SUBDIVISION AUTHORITY MINUTES MEETING NO. 13

Tentative plan of subdivision to create one (1) multi-unit housing lot (MHL) and one (1) Municipal Reserve lot from Lot 2, Block 6A, Plan 922 0135, located northwest of Blatchford Road NW and west of Bravo Boulevard NW;
BLATCHFORD

File No. LDA23-0336

RE: Tentative plan of subdivision to create one (1) multi-unit housing lot (MHL) and one (1) Municipal Reserve lot from Lot 2, Block 6A, Plan 922 0135, located northwest of Blatchford Road NW and west of Bravo Boulevard NW; **BLATCHFORD**

SUBDIVISION CONDITIONS OF APPROVAL MAP

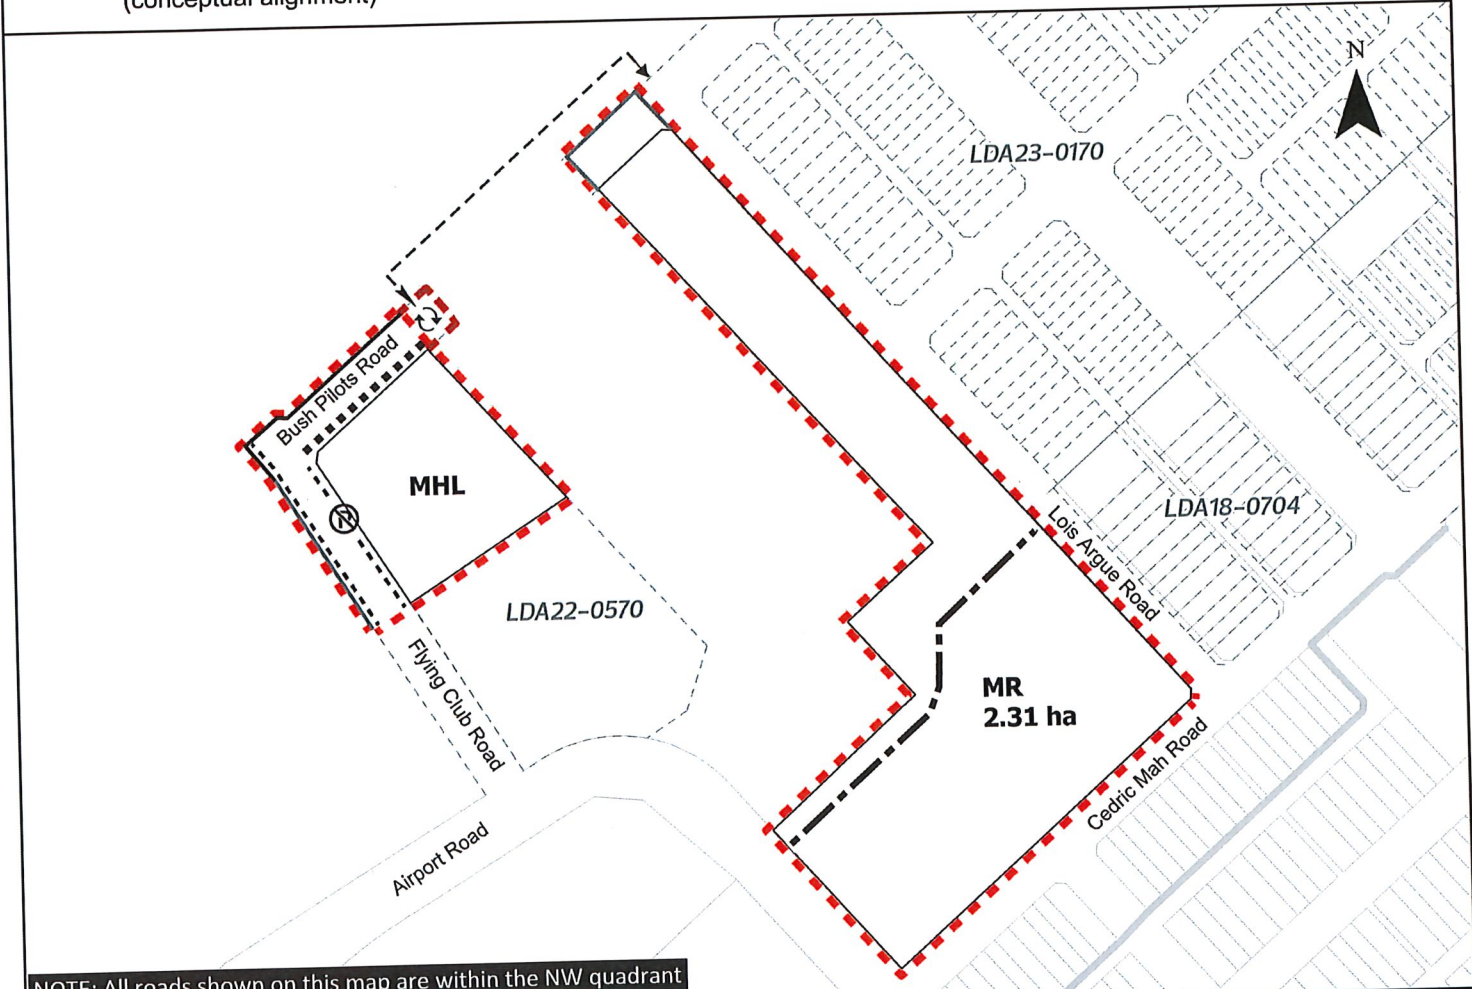
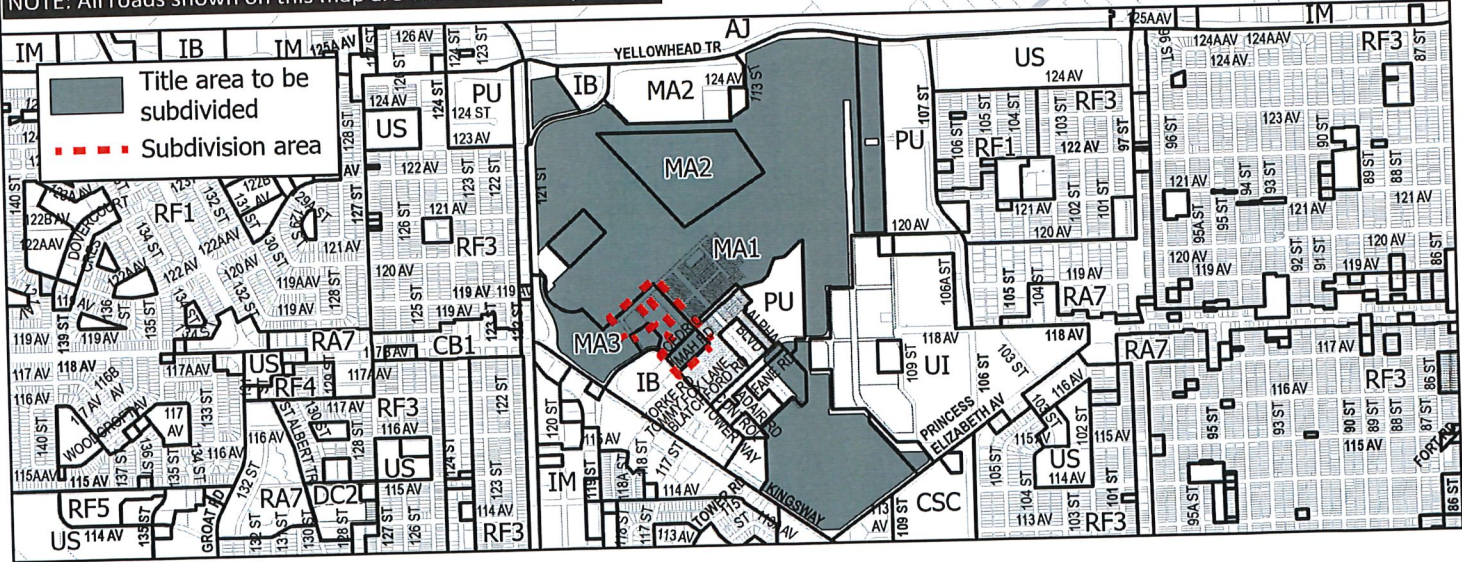
1. that the owner dedicate Municipal Reserve (MR) as a 2.31 ha lot pursuant to Section 666 of the Municipal Government Act, as shown on the "Conditions of Approval" map, Enclosure I;

6. that the subdivision boundary be amended to include the dedication of a portion of Bush Pilots Road NW to conform to an approved Concept Plan, or to the satisfaction of Subdivision and Development Coordination, as shown on the "Conditions of Approval" map, Enclosure I;

7. that the owner construct Flying Club Road NW as an "Active Street" to an approved design and cross-section in accordance with the Complete Streets Design and Construction Standards, including the construction of 2.1 m concrete sidewalks on both sides, to the satisfaction of Subdivision and Development Coordination, as shown on the "Conditions of Approval" map, Enclosure I;

8. that the owner construct Bush Pilots Road NW as a "Quiet Street" to an approved design and cross-section in accordance with the Complete Streets Design and Construction Standards, including the construction of 3 m shared use path on south side, to the satisfaction of Subdivision and Development Coordination, as shown on the "Conditions of Approval" map, Enclosure I;

10. that the owner pay for installation of "no parking" signage on the east side of the Flying Club Road NW to the satisfaction of Subdivision and Development Coordination and Fire Rescue Services, as shown on the "Conditions of Approval" map, Enclosure I;

11. that the owner construct a temporary 12 m radius gravel surface turnaround with bollards or mini-barriers to the satisfaction of Subdivision and Development Coordination, as shown on the "Conditions of Approval" map, Enclosure I. This turnaround will be required prior to Construction Completion Certificate (CCC) for roads (or at the discretion and direction of Subdivision and Development Coordination);

12. that the owner construct a temporary 4 m wide gravel surface emergency access with T-bollards, as shown on the "Conditions of Approval" map, Enclosure I. This roadway will be required prior to CCC for roads (or when required by Subdivision and Development Coordination);
13. that the owner designs the ultimate North Storm Water Management Facility (SWMF) and constructs the Stage 1 North SWMF, including all necessary inlets and outlets, to the satisfaction of Subdivision and Development Coordination; and
14. that the owner is responsible for the landscape design and construction within the Reserve lot and road right of way, to the satisfaction of City Departments and affected utility agencies.

TENTATIVE PLAN

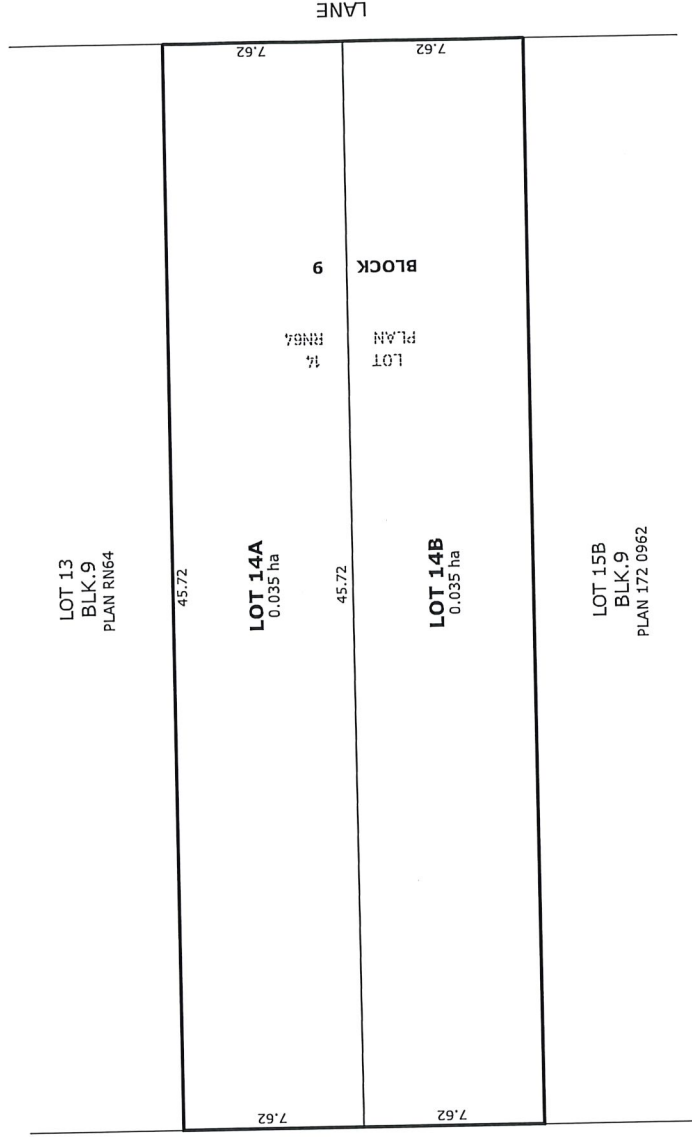
1. that the owner make satisfactory arrangements with EPCOR Water Services Inc. and EPCOR Drainage Services for the provision of separate services (water and sewer) to the proposed southern lot; and
2. that the owner pay all outstanding property taxes prior to the endorsement of the plan of survey.

- The existing services (water and sanitary) enter the proposed subdivision approximately 1.52 m south of the north property line of Lot 14A off the lane. As per the EPCOR Drainage Services Bylaw and the EPCOR Water Services and Wastewater Treatment Bylaw, these services cannot cross the proposed property line.

- There is a deficiency in on-street hydrant spacing adjacent to the property. The applicant/owner is advised to review on-site fire protection requirements to ensure adequate coverage (contact EPCOR Water at 780-412-3955).

- Overhead power lines are located on or adjacent to the subject site. It is important to prevent structural conflicts with electrical equipment. At the Development Permit stage, power poles, transformers, and other electrical equipment near the subject site must be included on all site plans and drawings. If a structure is greater than 5.5 m in height and has a setback of 4.5 m or less from the property line, please advise EPCOR Power's Customer Engineering Services (CES@epcor.com or 780-412-3128). They will provide feedback from a safety perspective, to help ensure Alberta Electrical Utility Code clearance requirements are achieved. For more information, refer to EPCOR Power's website at www.epcor.com (search "Building Structures and Power Equipment Clearances").

KING EDWARD PARK
TENTATIVE PLAN SHOWING PROPOSED
SUBDIVISION

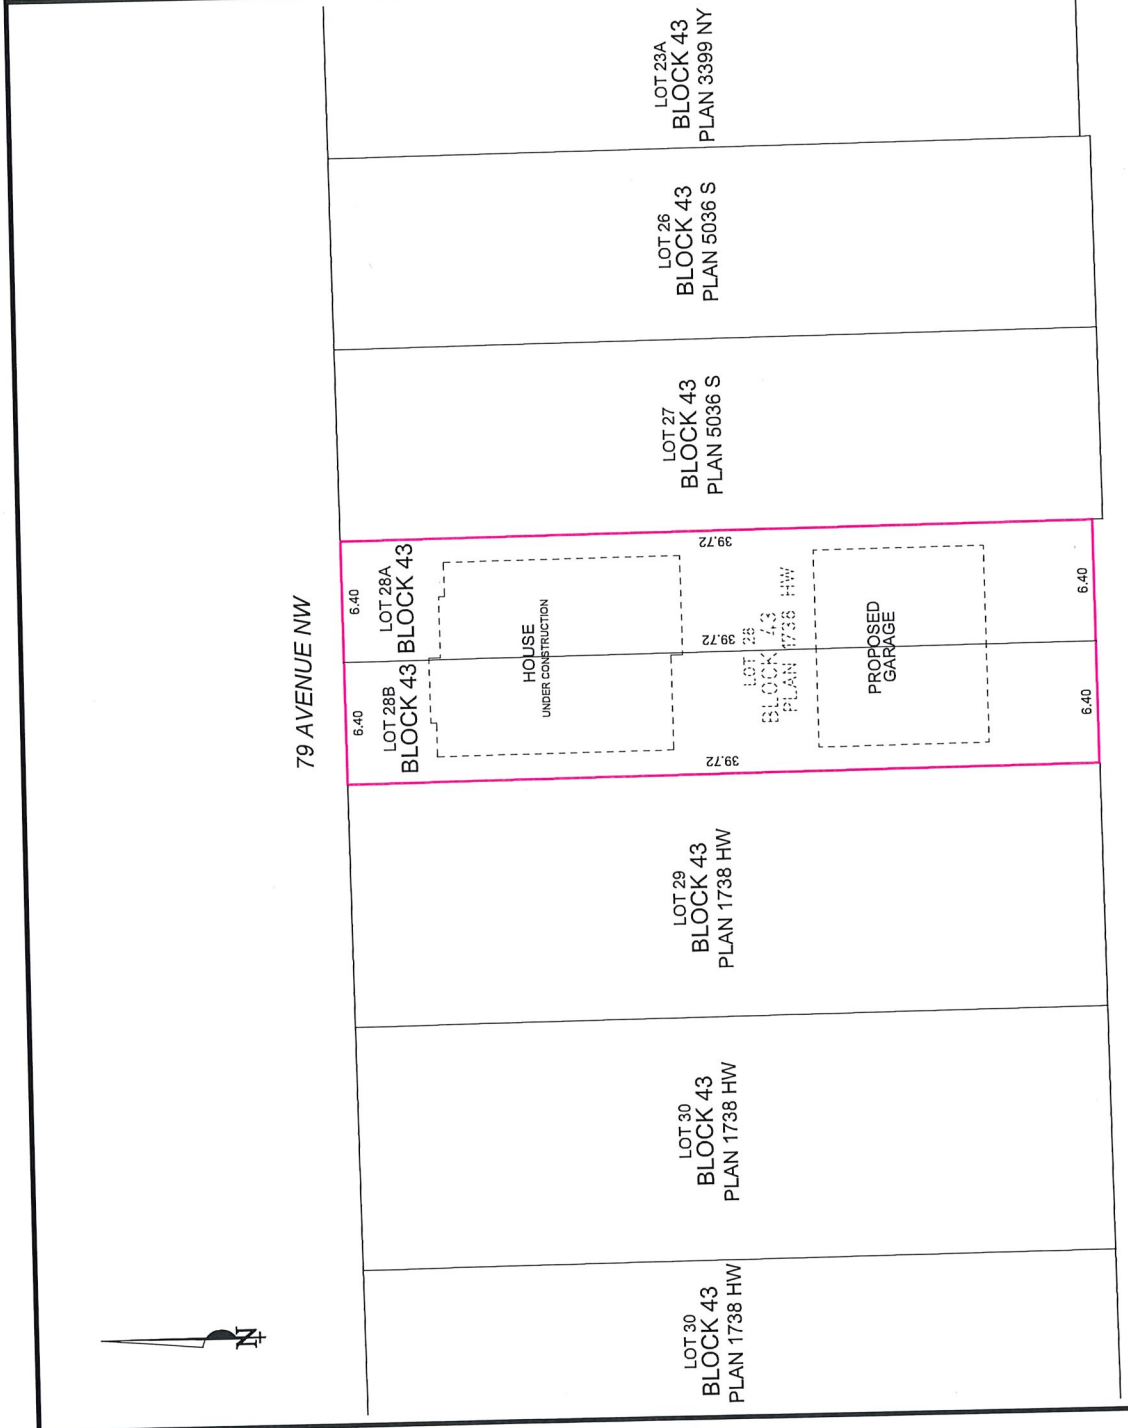
- The existing services (water and sanitary) enter the proposed subdivision approximately 5.18 m west of the east property line of Lot 28A off the lane and, 2.065 m east of the west property line of Lot 28B off the lane. As per the EPCOR Drainage Services Bylaw and the EPCOR Water Services and Wastewater Treatment Bylaw, these services cannot cross the proposed property line.

- There is a deficiency in on-street hydrant spacing adjacent to the property. The applicant/owner is advised to review on-site fire protection requirements to ensure adequate coverage (contact EPCOR Water at 780-412-3955).

TENTATIVE PLAN SHOWING PROPOSED
SUBDIVISION

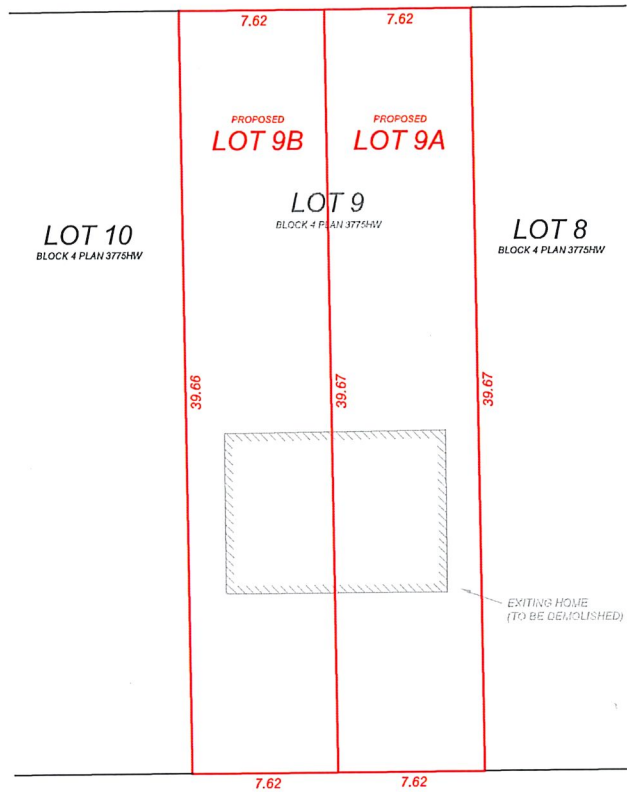
- The existing services (water and sanitary) enter the proposed subdivision approximately 6.94 m east of the west property line of Lot 9A off the lane. As per the EPCOR Drainage Services Bylaw and the EPCOR Water Services and Wastewater Treatment Bylaw, these services cannot cross the proposed property line.

- There is a deficiency in on-street hydrant spacing adjacent to the property. The applicant/owner is advised to review on-site fire protection requirements to ensure adequate coverage (contact EPCOR Water at 780-412-3955).

- Overhead power lines are located on or adjacent to the subject site. It is important to prevent structural conflicts with electrical equipment. At the Development Permit stage, power poles, transformers, and other electrical equipment near the subject site must be included on all site plans and drawings. If a structure is greater than 5.5 m in height and has a setback of 4.5 m or less from the property line, please advise EPCOR Power's Customer Engineering Services (CES@epcor.com or 780-412-3128). They will provide feedback from a safety perspective, to help ensure Alberta Electrical Utility Code clearance requirements are achieved. For more information, refer to EPCOR Power's website at www.epcor.com (search "Building Structures and Power Equipment Clearances").

TENTATIVE PLAN

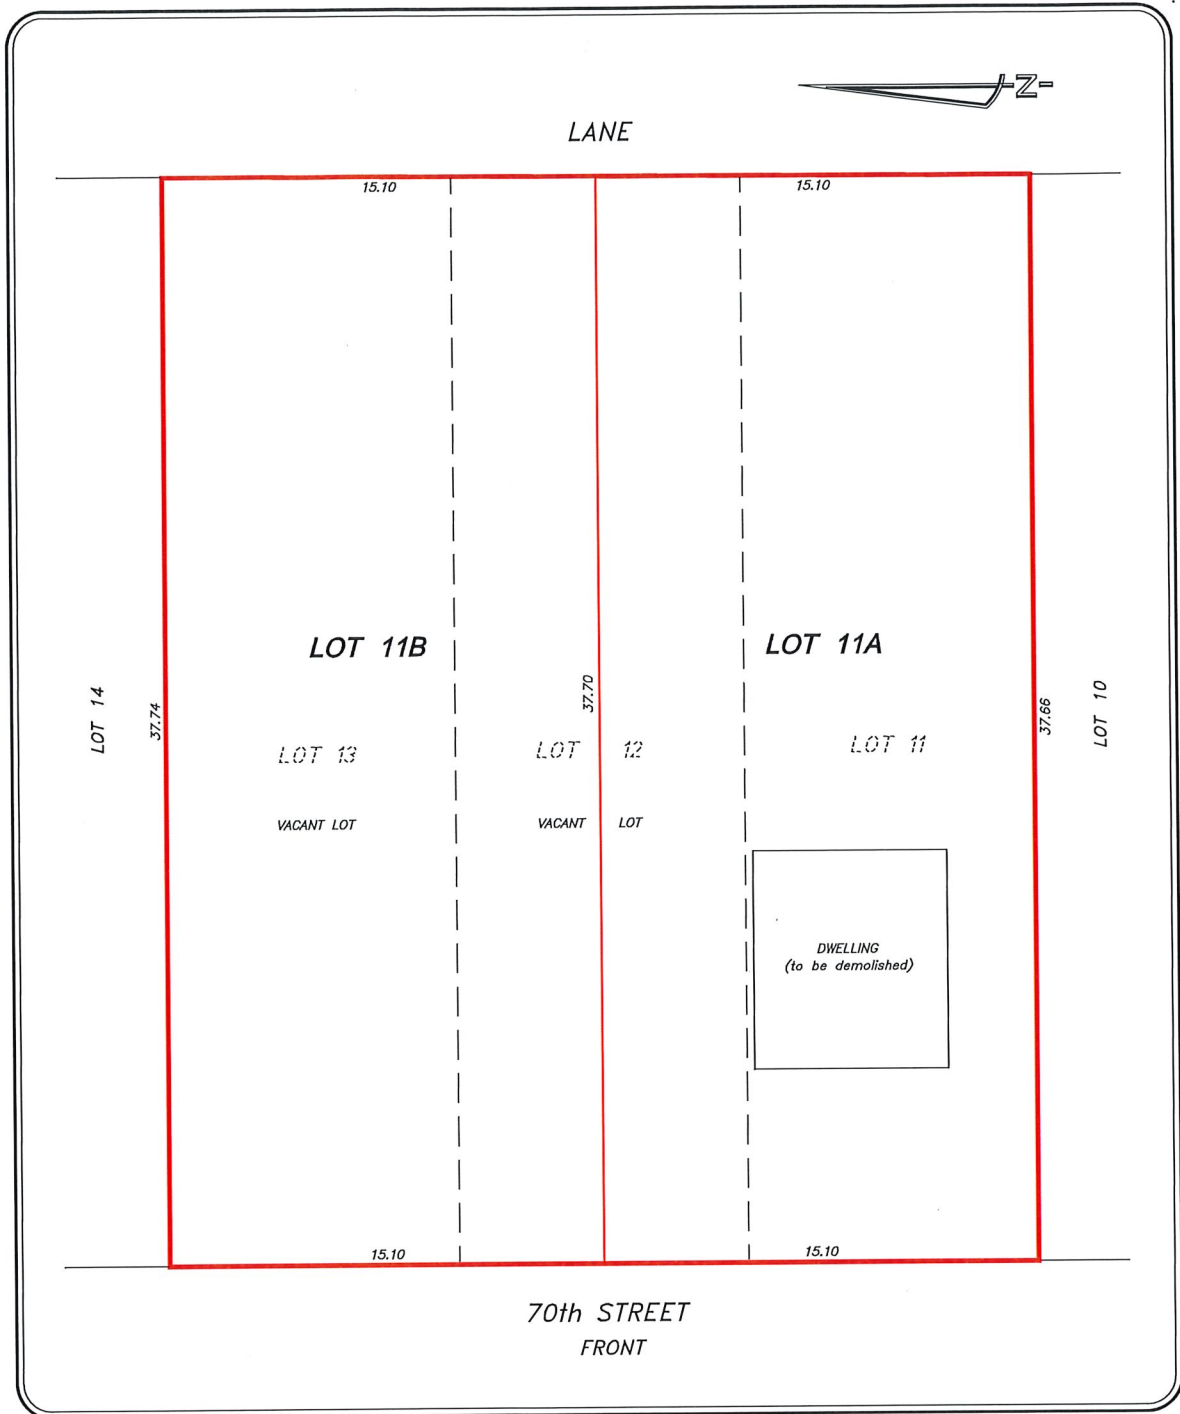
1. that the owner remove and replace the existing lead water service to proposed Lot 11B (contact EPCOR Water Services at 780-412-6858);
2. that the owner apply for a permit to demolish the existing dwelling prior to endorsement of the final plan. Demolition permits can be obtained from Development Services. Apply online at www.edmonton.ca/permits; and
3. that the owner pay all outstanding property taxes prior to the endorsement of the plan of survey.

- Access for future development must be to the adjacent alley as per the General Regulations (Section 6.1) of the 2.30 RSM h12 - Small-Medium Scale Transition Residential Zone of Zoning Bylaw 20001.

- The existing concrete stairs that encroach onto the 70 Street NW road right-of-way must be removed with future redevelopment of the site, or the owner must enter into an Encroachment Agreement with the City of Edmonton. Permanent objects are not permitted to encroach within road right-of-way without entering into an Encroachment Agreement with the City of Edmonton. Email encroachmentagreements@edmonton.ca for more information..

- The owner is required to make satisfactory arrangements for, and pay all costs associated with separate servicing to each lot, as well as the modification, relocation and/or removal of existing services. For further information, please contact: EPCOR Distribution & Transmission Inc. (780-412-4000), TELUS Communications (Edmonton) Inc. (Real Estate Division [Rights of Way] 780-508-2456), ATCO Gas (780-424-5222), and EPCOR Drainage Services (Water and Sewer Servicing 780-496-5444).
- The existing services (water and sanitary) enter the proposed subdivision approximately 6.43 m north of the south property line of Lot 11, off the lane. Existing sanitary service also enters the proposed subdivision approximately 5.16 m south of the north property line of Lot 13, off of the lane.

As per the EPCOR Drainage Services Bylaw and the EPCOR Water Services and Wastewater Treatment Bylaw, these services cannot cross the proposed property line.
